Subject: 10CFR21 Reporting of Defects and Non-Compliance -  
Engine Systems, Inc. Report No. 10CFR21-0136, Rev. 0

Voltage Regulator Chassis – Incorrect Bus Bar Installation  
P/Ns: 72-12300-100-ESI  
72-14200-100-ESI  
72-14000-100-6020

**10CFR21 REPORTING OF DEFECTS  
AND NON-COMPLIANCE**

COMPONENT: Voltage Regulator Chassis – Incorrect Bus Bar Installation  
P/Ns: 72-12300-100-ESI  
72-14200-100-ESI  
72-14000-100-6020

Photo 1: Incorrectly Installed Bus Bar

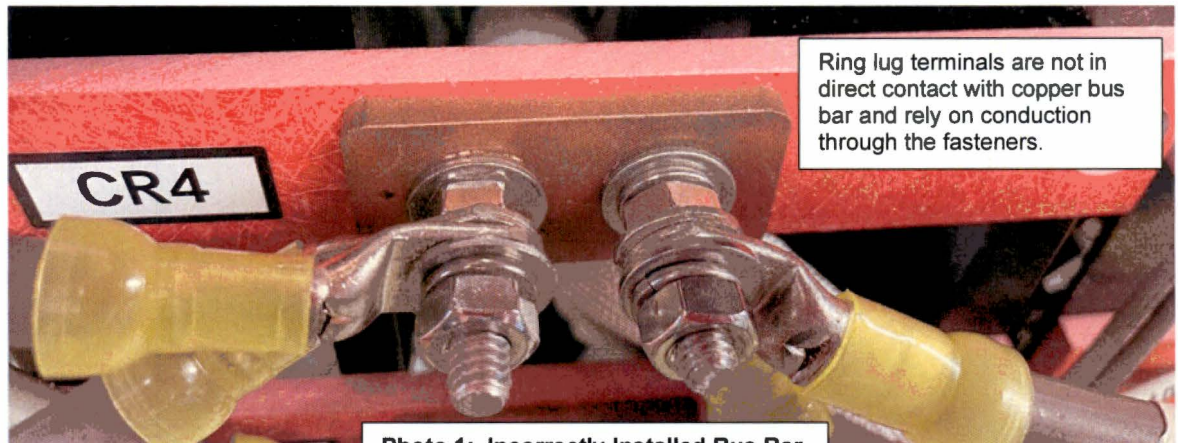
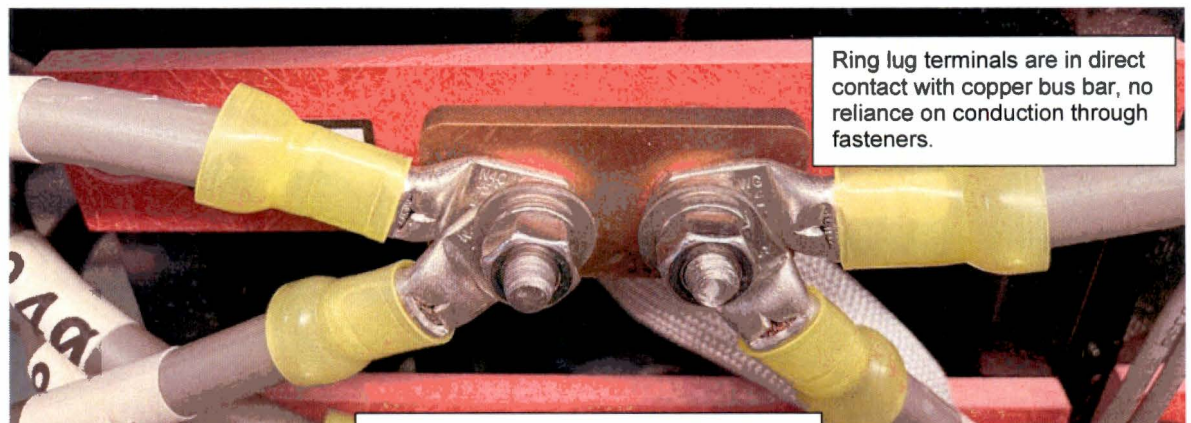
*Copper bus bars are used at rectifier diode pigtail connections CR1, CR2, CR3, CR4, and CR7 to provide a common connection point for associated wiring to minimize the number of conductors on a single fastener. It is intended for the conductors to clamp directly to the bus bar, thereby maintaining a low resistance conduction path between components. ESI has determined the bus bars were installed incorrectly whereby the conductors are not clamped in direct contact, resulting in current flow through the stainless steel fasteners. This configuration is undesired and will result in unnecessary heat generation which may lead to failure of the connection and therefore failure of the automatic voltage regulator (AVR) assembly. The AVR is relied upon to automatically regulate emergency diesel generator (EDG) terminal voltage. Failure of the AVR would impact ability of the EDG to perform its safety-related function and therefore may impact the nuclear plant's ability to manage safety-related loads during an emergency event.*

*Photos below show an example of an incorrectly installed bus bar (photo 1) and one that is correctly installed that ensures proper conduction (photo 2). Photos and figures on the following pages provide additional information.*

*Bus bar installation should be corrected immediately by restacking the components to ensure direct contact with all conductors. See section viii below for details.*

**Figure 1: Cross Section - Incorrect Bus Bar Install**  
(Note bus bar is not in direct contact with wire lug and diode pigtail)

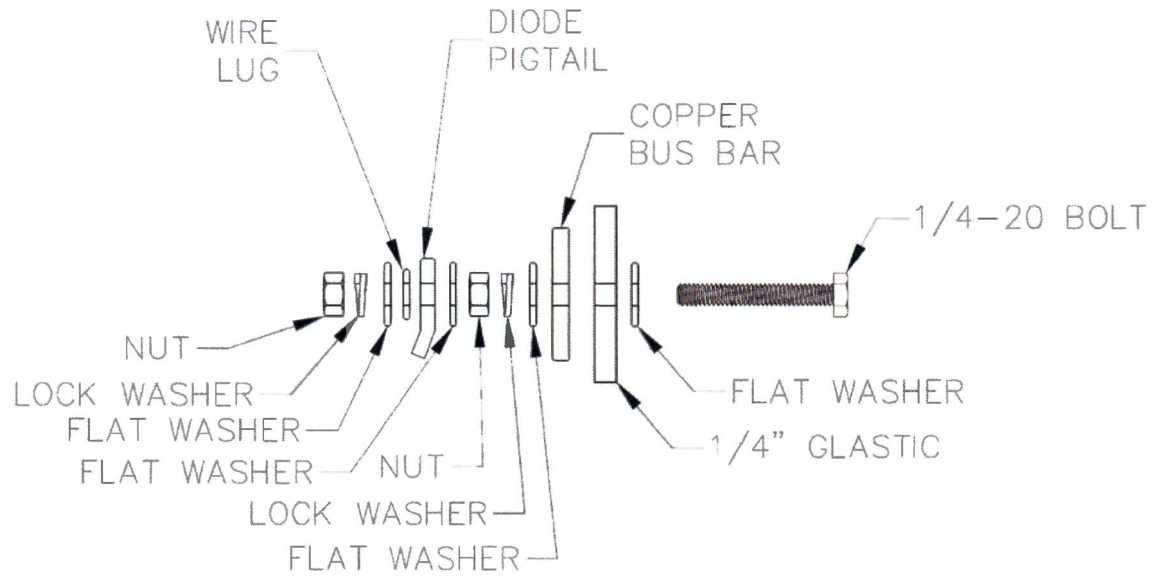
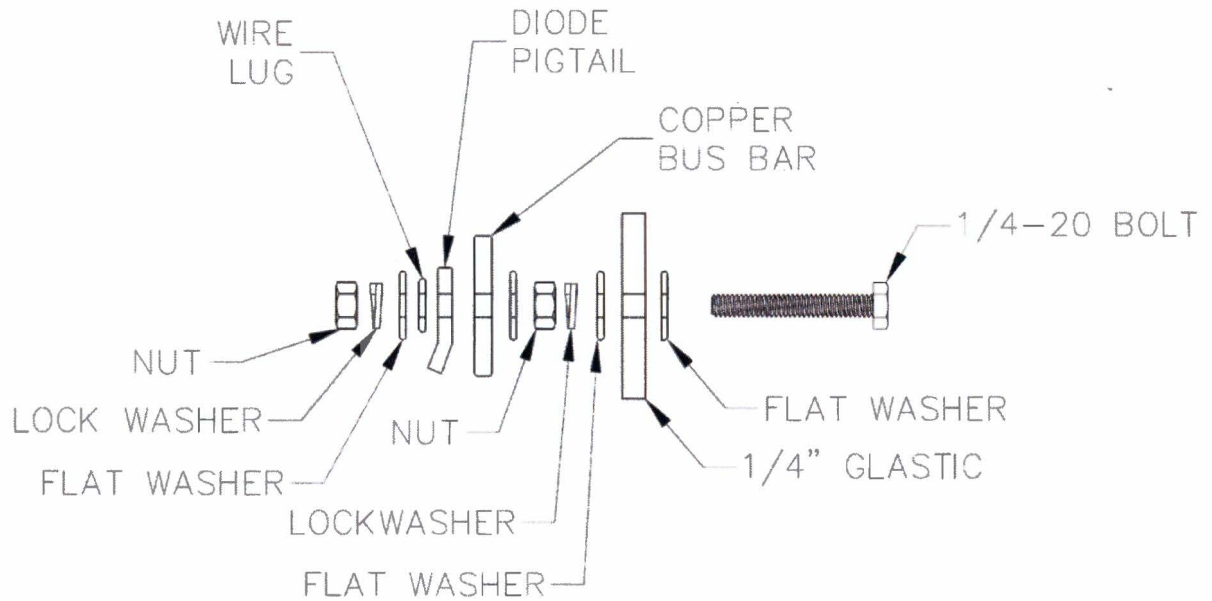
**Figure 2: Cross Section - Correct Bus Bar Install**  
(Note wire lug, diode pigtail, and bus bar stacked in direct contact)

Photo 3: Chassis - Upper Half

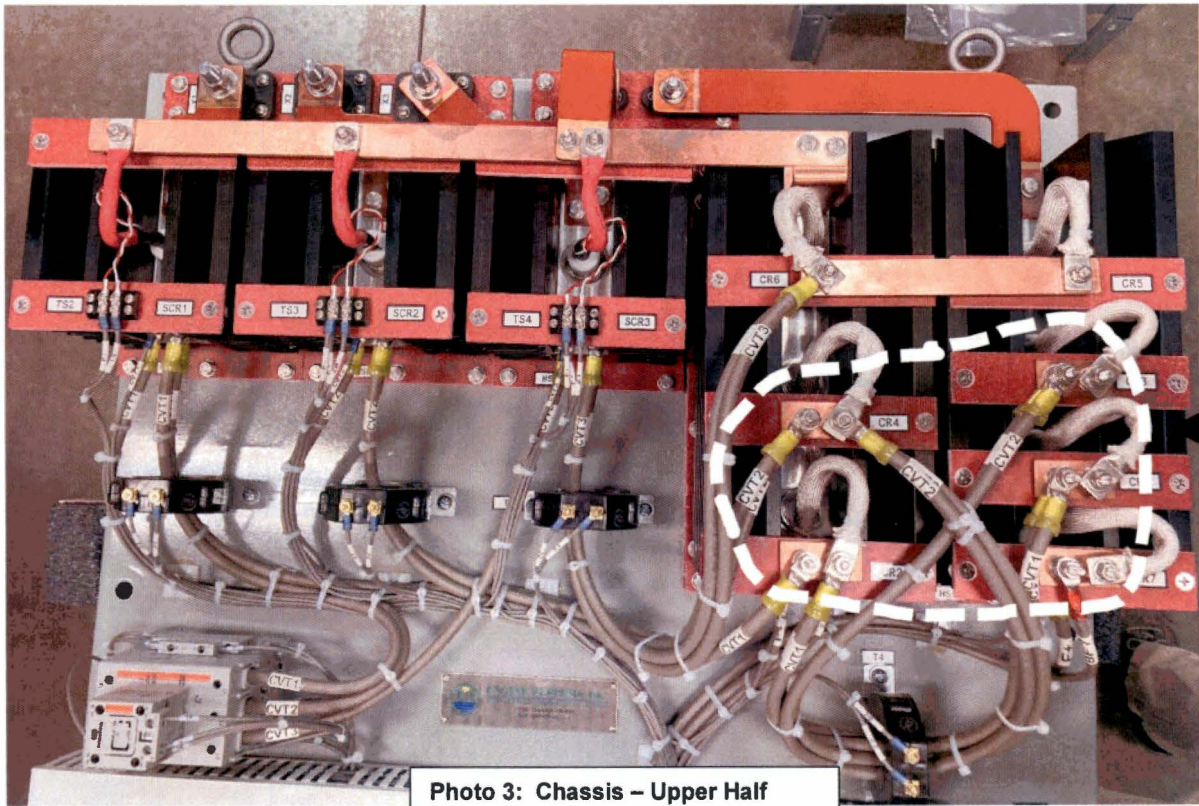
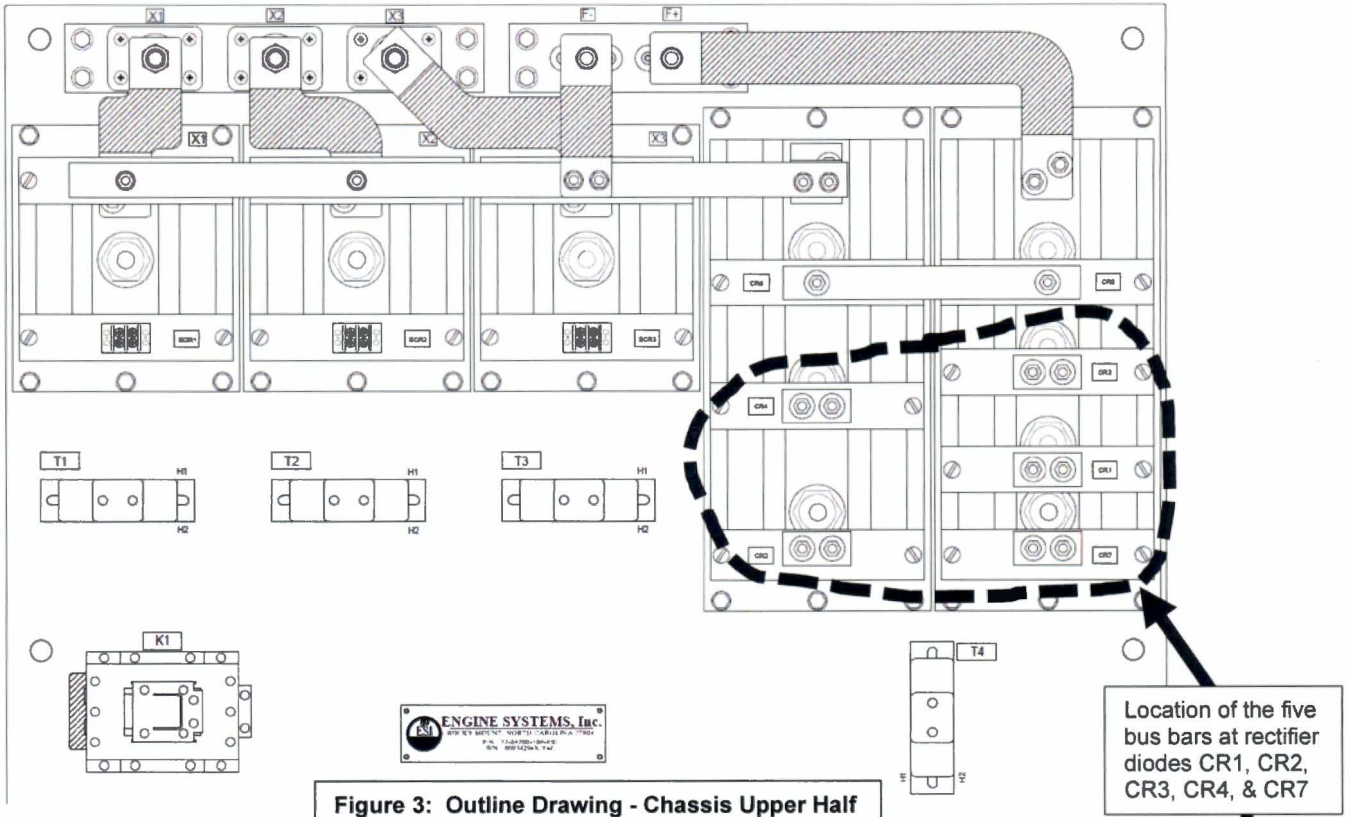
Figure 3 and photo 3 below show location of the bus bars on the voltage regulator chassis.
